**Re: NPDES Permit Renewal Application Revision
DTE Electric Company – Monroe Power Plant (MONPP)
NPDES Permit No. MI0001848**

The DTE Electric Company (Company) is submitting a revision to the NPDES permit renewal application dated April 4, 2014, for the above-reverenced facility. This revision is based on your e-mail request dated November 26, 2014, and pertains to Section VI (Cooling Water Intake Structures, or CWIS) of the renewal application. The original application provided the information by referencing the Report on Source Water and Cooling Water Data and Impingement Mortality and Entrainment Characterization for Monroe Power Plant (Characterization Report), dated July 2008. This comprehensive report was previously submitted to the MDEQ at the time it was written. We understand that your request is based on the additional information that the Characterization Report did not provide.

Velocity Calculations

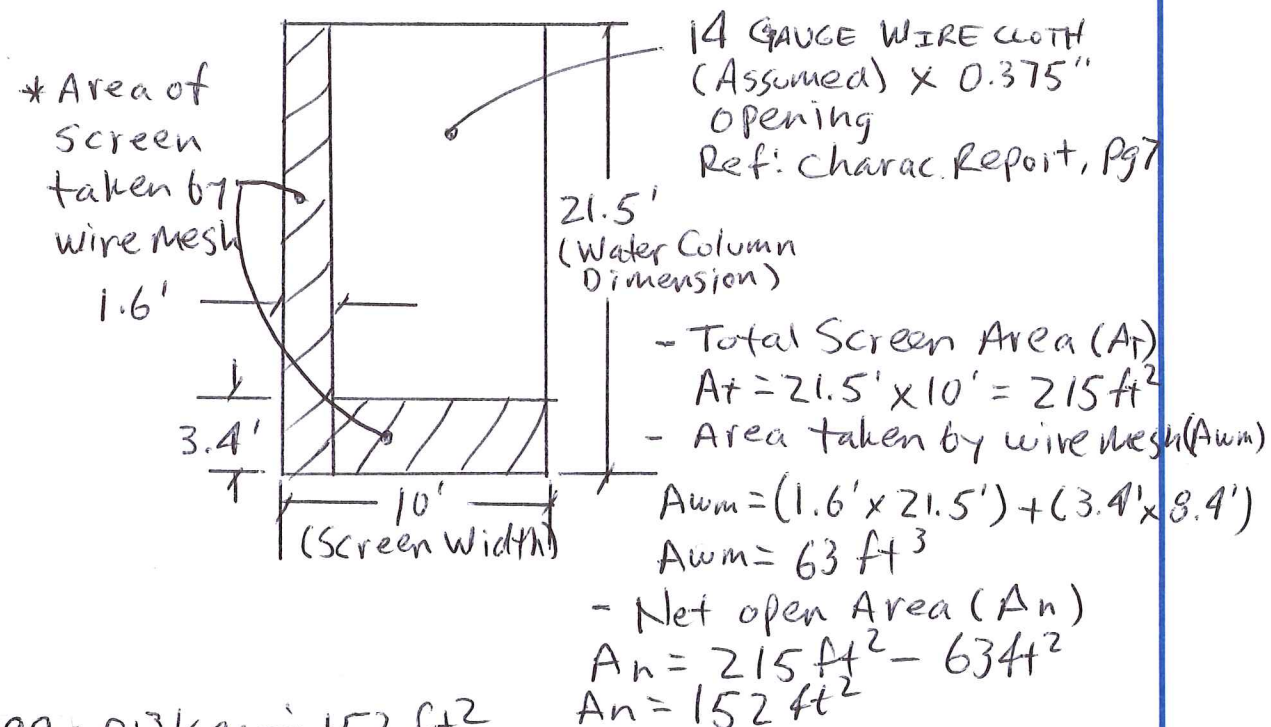
- 3. Provide the calculation of the maximum design through-screen intake velocity (the applicant may also submit the maximum actual through-screen velocity). {You should submit both velocities. For your facility, I suggest that you calculate these velocities at the traveling screens, the trash racks, and the intake canal.}**

- V_{3a} : Approach Velocity @ Screen House #1 (each Screen)

$$V_{3a} = 199 \text{ ft}^3/\text{sec} \div (21.5' \times 10')$$

$$V_{3a} = 0.93 \text{ ft/sec}$$

NOTE: Each Screen is 10' wide
Characterization Report, Pg. 7
